FutureGen Industrial Alliance, Inc. 73 Central Park Plaza East Jacksonville, IL 62650 www.FutureGenAlliance.org

Subject: Request for Additional Information #2 Regarding, FutureGen Applications for UIC Permit nos. IL-137-6A-0001, -0002, -0003 & -0004, November 14, 2013

11-14-2013:	Letter from Rebecca Harvey (EPA) to Kenneth K. Humphreys (Alliance), "Request for Additional Information Regarding four FutureGen 2.0 Wells, United States Environmental Protection Agency Underground
	Injection Control (UIC) Permit Applications for Four Geologic Sequestration Wells; United States Environmental Protection Agency UIC Permit Nos. IL-137-6A-0001, -0002, -0003, & -0004

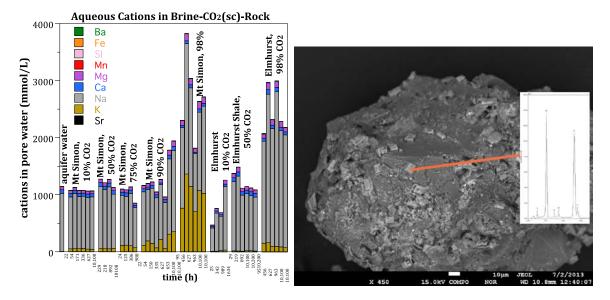
Requests based	d on the text app	plication	1				
RAI#	Subject	Page	Doc. Sec.	Par.	EPA Comment / Question / Request	FutureGen Response	Footnote / Reference Citation
11-14-2013_001	Physical Processes Modeled	3.3	3.1.2		"Page 3.3 of the permit application states that laboratory investigations for quantifying the importance of chemical reactions are being conducted. Are any results available? Modeling considering reactive transport may need to be conducted if the lab results indicate significant iron carbonate precipitation that changes injection zone porosity."	Based on its experiments, the FutureGen Alliance (the Alliance) expects to see a small mass of precipitates (KCl, NaCl) forming near the injection well from the scCO ₂ displacement of water, and does not expect to see the formation of any significant carbonate precipitates in this year (or years) time scale. Iron does precipitate, but concentrations are too low (<0.6 mmol/L) relative to carbonate mass to be a precipitate issue. Simulations by others (White et al. 2005) of scCO ₂ injection in a similar sandstone (also containing iron oxides) shows that over significantly longer time scales (1000+ years), alumino silicate dissolution and alumino silicate precipitation incorporating significant carbonate (dawsonite) is predicted, as well as precipitation of some calcite. That predicted mineral trapping did permanently sequester 21% of the carbonate mass, thus decreasing scCO ₂ transport risk. A more detailed response to this request showing some experimental results is presented in Appendix A.	White, S.P., R. Allis, J. Moore, T. Chidsey, C. Morgan, W. Gwynn, and M. Adams. 2005. Simulation of reactive transport of injected CO ₂ on the Colorado Plateau, Utah, USA. <i>Chemical Geology</i> 217:387–405.

The FutureGen Alliance (the Alliance) has experimentally investigated a number of geochemical, microbial, and physical processes related to supercritical carbon dioxide (scCO₂) injection into the upper Mount Simon Sandstone, which do show some precipitation at high scCO₂ concentrations. Over the long term (1,000s of years or longer), simulations by others show that scCO₂ storage as precipitates is expected to be a dominant process (Gaus et al. 2008, in Fig 2; White et al. 2005, simulation in sandstone with shale cap rock), where 20 to 50% of the carbon mass is permanently sequestered as a mineral.

The experiments were conducted at different brine/scCO2 ratios (0% to 98% scCO₂) in Mount Simon Sandstone, Eau Claire shale, and St. Peter Sandstone formations for the purpose of characterizing a) changes in water quality, and b) significant phase changes (i.e., precipitates) that may affect further injection. NaCl and KCl precipitates were observed forming at high scCO₂/brine ratios (Figure 1b) over time, as water partitions into the scCO₂, leaving ions behind that eventually precipitate (i.e., "salting out"). This is most likely to occur near injection wells. Major ion changes over the year (Figure 1a) are generally small, with only Na⁺ and K⁺ increase with 98% scCO₂ (with a corresponding increase in Cl⁻ [not shown]). Iron is observed to precipitate at nearly all scCO₂/brine ratios, but given the initial iron concentration of 0.6 mmol/L, the formation of siderite [Fe(II)CO₃] is expected only to be a relatively minor precipitate, and was not observed in the microprobe analysis of the scCO₂-treated Mount Simon samples. There were indications of mineral dissolution, with increasing Mg²⁺, K⁺, and SO₄²⁻ concentrations (10s to 100s of mmol/L) and a minor increase in silica. In the White et al. (2005) simulations, as the pH increased from 3.8 (acidic due to the scCO₂) to 4.8 over 105 years, the major mineral precipitates formed were aluminosilicates kaolinite [Al₂Si₂O₅(OH)₄] and dawsonite [NaAlCO₃(OH)₂], with a small increase in calcite precipitation, with corresponding dissolution of aluminosilicates albite [NaAlSi₃O₈], anorthite [CaAl₂Si₂O₈], and K feldspar [KAlSi₃O₈].

Therefore, the Alliance expects to see a small mass of precipitates (KCl, NaCl) forming near the injection well from the $scCO_2$ displacement of water, and does not expect to see the formation of any significant carbonate precipitates in this year (or years) time scale. Iron does precipitate, but concentrations are too low (<0.6 mmol/L) relative to carbonate to be a precipitate issue. Modeling by others (White et al.2005) in a similar sandstone (also containing iron oxides) shows that over significantly longer time scales (1,000+ years) significant aluminosilicate dissolution and aluminosilicate precipitation incorporating significant carbonate (dawsonite) is predicted, as well as some precipitation of calcite. That predicted mineral trapping did permanently sequester 21% of the carbonate mass, thus decreasing $scCO_2$ transport risk.

Figure 3.21. CO₂-Rich Phase Saturation for the Representative Case Scenario Simulations Shown at Selected Times (5, 10, 20, 70, and 100 years).

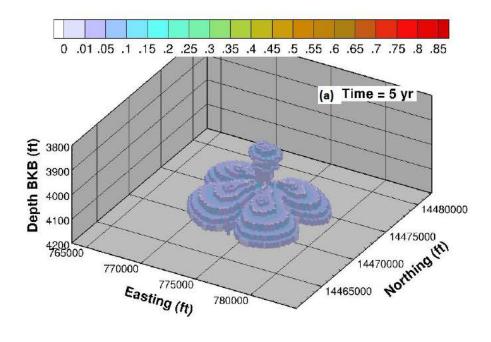
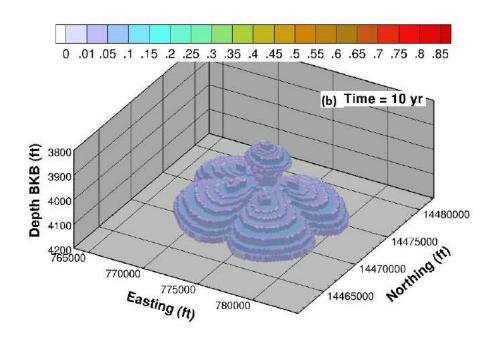
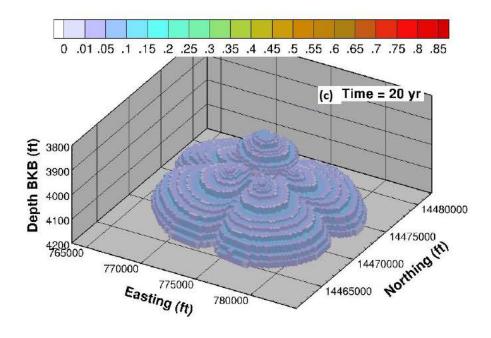
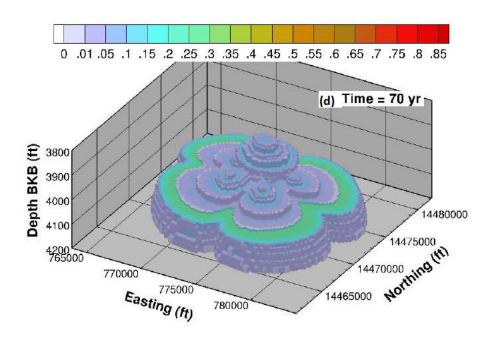
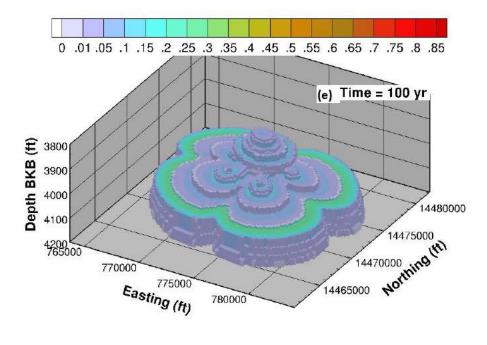
11-14-2013_010	Computational Model Results		3.1.6	2	"Please provide figures beyond year 70. We suggest figures to year 100."		
11-14-2013_011	Parameter Sensitivity and Uncertainty		3.1.10	1	"32 cases were defined using "quasi Monte Carlo" approach. This approach should be described and possibly cited."	An extensive response to RAIs 11-14-2013_011 and 11-14-2013_012 is presented in Appendix D.	
11-14-2013_012	Parameter Sensitivity and Uncertainty		3.1.10	2	"The permit application states that 32 cases were defined from the representative case model. The parameter values used for these 32 cases should be presented in a table."

The last paragraph and associated figures of Section 3.1.6 (Computational Model Results), beginning on page 3.29, were updated (as excerpted below) to describe the CO_2 migration processes. In addition, a plot corresponding to 100 years was added to each of the following figures: 3.21, 3.22, and 3.23. Furthermore, Figure 3.24 was replaced with plots showing the pressure differential and the CO_2 plume boundary at the same scale and in the horizontal plane (map view) for the same times. For convenience, the plots in each figure are marked with letters "a" through "e." Please refer to the response to RAI# 11-14-2013 018 for information about the pressure front.

"Reservoir conditions are such that the CO_2 remains in the supercritical state throughout the domain and for the entire simulation period. The three-dimensional distribution of the CO_2 -rich (or separate-) phase saturation is presented for selected times (i.e., 5, 10, 20, 70, and 100 years) in Figure 3.21. Additionally, and to better illustrate the CO_2 migration through time and space, a cross-sectional view of the CO_2 plume is presented as slices through the center of the injection wells and along the well traces (see Figure 3.18 for location of cross sections). Figure 3.22 and Figure 3.23 show the CO_2 -rich (or separate) phase saturation for selected times for slices A-A' and B-B', respectively. Note that Figure 3.21 shows the plume in model coordinate space, while Figure 3.22 and Figure 3.23 show the distance from the center of the injection well pad. This is necessary because the well orientation is not aligned with the x and y axes of the model domain.

The cloverleaf pattern of the CO₂ plume that forms as a result of the four lateral-injection-well design can be seen in Figure 3.21a, which shows the plume after 5 years of continuous CO2 injection. The central portion of the plume is a result of CO₂ injection into the Elmhurst in the vertical section of each well. Figures presenting the cross-sectional views show the location of the open interval relative to the plume and stratigraphic units. It can be seen in Figure 3.22 and Figure 3.23 that after 5 years of continuous CO₂ injection, the plume has spread both laterally and vertically, with some CO_2 migrating into the lower part of the Lombard. At 10 and 20 years, with more CO_2 being injected, the plume grows larger with time primarily in the lateral direction, but also vertically. Two years after the cessation of CO_2 injection (at 22) years), the plume reaches its maximum lateral extent (a comparison of the plume outline at different times in plan view is shown in Figure 5.1). However, the CO₂ within the plume continues to redistribute by migrating slowly upward due to buoyancy effects, with some of the CO₂ dissolving at the CO₂-brine interface at the edge of the plume. The vertical layering represented in the model is one of the controlling factors in the plume shape at later times. In general, the CO_2 tends to accumulate below a layer with a relatively higher gas entry pressure (and often lower permeability) than that of the layer directly below it. This area of relatively higher CO2 saturation can be seen in Figure 3.21d and Figure 3.21e as the green "ledge" feature in the plume, and in Figure 3.22d, Figure 3.22e, Figure 3.23d, and Figure 3.23e as the flat-topped orange zone. Because the plume migrates primarily upward after injection ceases, the green feature becomes narrower with time (Figure 3.21d and Figure 3.21e). The vertical cross sections showing the plume at 100 years illustrate how the CO₂ distribution within the plume becomes more uniform with time (Figure 3.22e and Figure 3.23e). Because of the dissolution process, the CO_2 separate-phase plume area (in the horizontal plane) at 100 years is 2.2% smaller than the maximum area at 22 years.

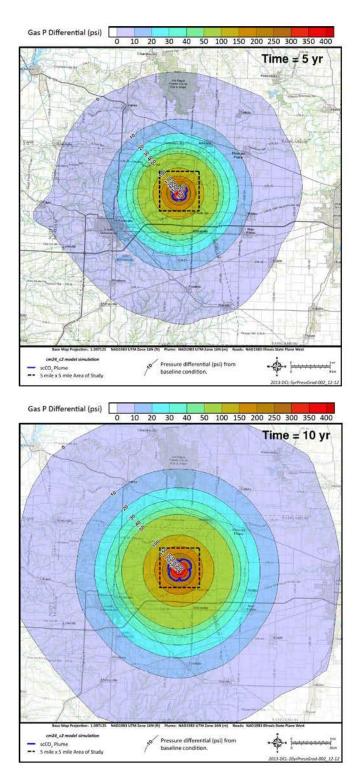
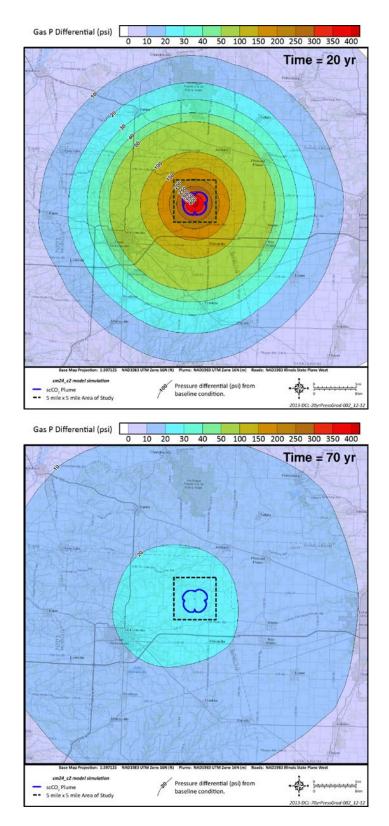
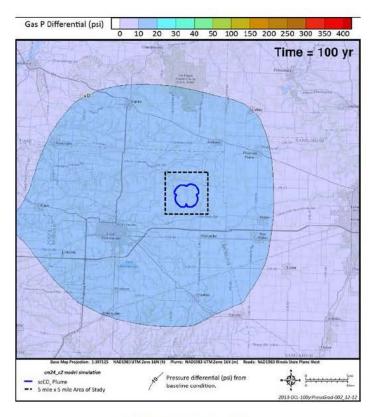
,	- (,	, <u>r</u>	F			
Requests base	d on the text ap	plication	1				
RAI#	Subject	Page	Doc. Sec.	Par.	EPA Comment / Question / Request	FutureGen Response	Footnote / Reference Citation
11-14-2013_008	Representative Case Scenario Description	3.26	3.1.5		Section 3.1.5 of the permit application notes that the design of the injection wells was chosen to "avoid sensitive areas" (p. 3.26). What are these "sensitive areas" and how were they identified? Is this the reason the horizontal well legs are not evenly distributed in a radio fashion?	The "sensitive areas" are properties to which the project has not acquired pore space rights. These properties were avoided by orienting the horizontal legs of the injection wells.	
11-14-2013_009	Computational Model Results		3.1.6	1	"It would be helpful to have a verbal description of the changes between figures in a series: e.g., the 70yr figure in 3.21 has a wide area in green but the other three do not: what does this tell us? It is extremely difficult to judge scale from these figures. Please provide dimensions of plume and pressure front over time, together. A map view, such as Fig. 3.25, would be ideal. What is the largest extent of the plume and when does this occur? Because these figures are not at the same scale, they are hard to compare."	The complete response to RAIs 11-14-2013_009 and 11-14-2013_010 is provided in Appendix C. The last paragraph and associated figures of Section 3.1.6 (Computational Model Results), beginning on page 3.29 of the Supporting Documentation of the UIC Permit applications, were updated to describe the CO ₂ migration processes. The largest area of the plume is 6.46 mi ² and occurs at year 22.

A contour map of the pressure differential and the corresponding outline of the CO_2 plume boundary for selected times (i.e., 5, 10, 20, 70, and 100 years) are shown in Figure 3.24. The maximum pressure differential corresponds to the end of the injection period (year 20). After that time, the pressure slowly dissipates resulting in the maximum pressure differential being below 30 psi at 70 years (Figure 3.24d), and below 20 psi at 100 years (Figure 3.24e). Because there is a natural upward flow from the injection zone, a critical pressure has not been defined. Hence, we are presenting the pressure differential distribution instead of a defined pressure front (Figure 3.24).

Figure 1. Klinkenberg correction factor as a function of K-Klinkenberg for all analyzed FutureGen core plugs.

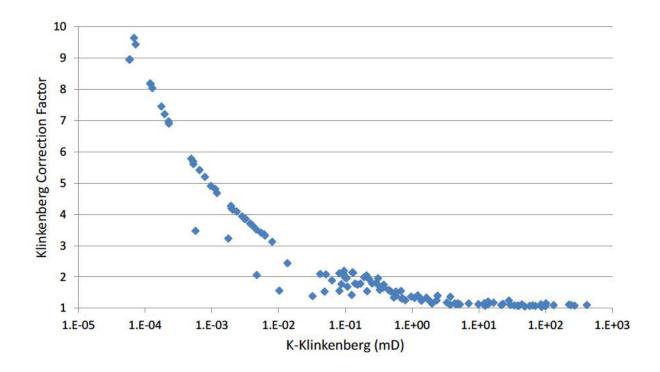
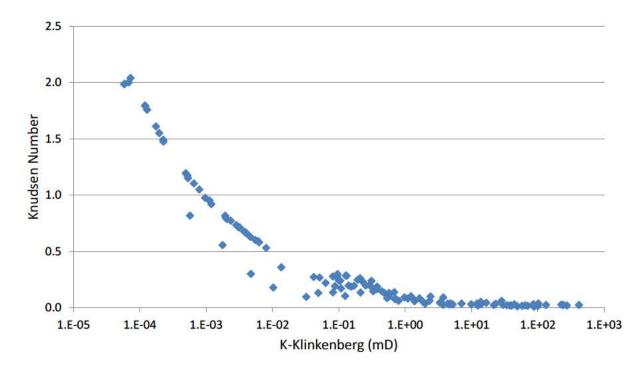
11-14-2013_015	Rocks Properties	2	"Horizontal intrinsic permeability of the confining zones (see p. 3.7 of the permit application). Because of the reliability issues associated with ELAN log derived permeabilities below a certain limit (0.01 mD), FutureGen used the horizontal Klinkenberg permeabilities for each model layer. Was there any correction applied to the Klinkenberg permeabilities used for the confining zone layers, particularly because these may represent tight porous formations?"	Additional permeability corrections beyond the Klinkenberg correction were not applied. The K-Klinkenberg values were computed from K-air values, measured by Core Laboratories using an unsteady state method, using the Klinkenberg Correction Factor (KCF). The KCF values were obtained for each sample using a standard procedure (Jones 1972). An extensive discussion is presented in Appendix E.	Jones, S.C. 1972. A rapid accurate unsteady-state Klinkenberg permeameter. Society of Petroleum Engineers Journal 383-397.

Additional permeability corrections beyond the Klinkenberg correction were not applied. The K-Klinkenberg values were computed from K-air values, measured by Core Laboratories using an unsteady-state method, using the Klinkenberg Correction Factor (KCF). The KCF values were obtained for each sample using a standard procedure (Jones 1972). For some tight rocks it has been shown that the KCF may not be sufficient and that larger correction factors, such as the Knudsen correction factor, might be needed. The determination of whether a standard Klinkenberg can be used is typically based on the values of the Knudsen number, Kn (Kn = λ /r where λ is the molecular free path and r is characteristic length such as pore radius). For Knudsen numbers below ~2, differences between the KCF and the Knudsen correction factor are relatively small and additional permeability corrections are typically not needed (e.g., Ziarani and Aguilera 2012).

In Figure 1 (below), the computed KCF values are plotted against K-Klinkenberg for all analyzed samples. The plots show that for the tighter rocks (K-Klinkenberg < 0.01 mD), the KCF are always less than 10. Based on literature analyses (e.g., Civan 2010; Ziarani and Aguilera 2012), KCF values less than 10 indicate that the tighter samples are, in terms of the Knudsen flow regime, located in the lower end of the transition flow zone where 0.1 < Kn < 10. To confirm this observation, Kn values are computed using Eq. D1 for λ and Eq 17 for r in Ziarani and Aguilera (2012) and plotted in Figure 2 vs. K-Klinkenberg. The plot shows that for the tighter cores, Kn < 2. For these Kn values, the Knudsen correction factor may be up to 10% to 20% larger than the KCF. However, given the inherent uncertainties of unsteady-state permeability measurements in the < 0.01 mD range (Rushing et al. 2004), the slightly larger correction factor would result in permeability values within the experiment measurement error.
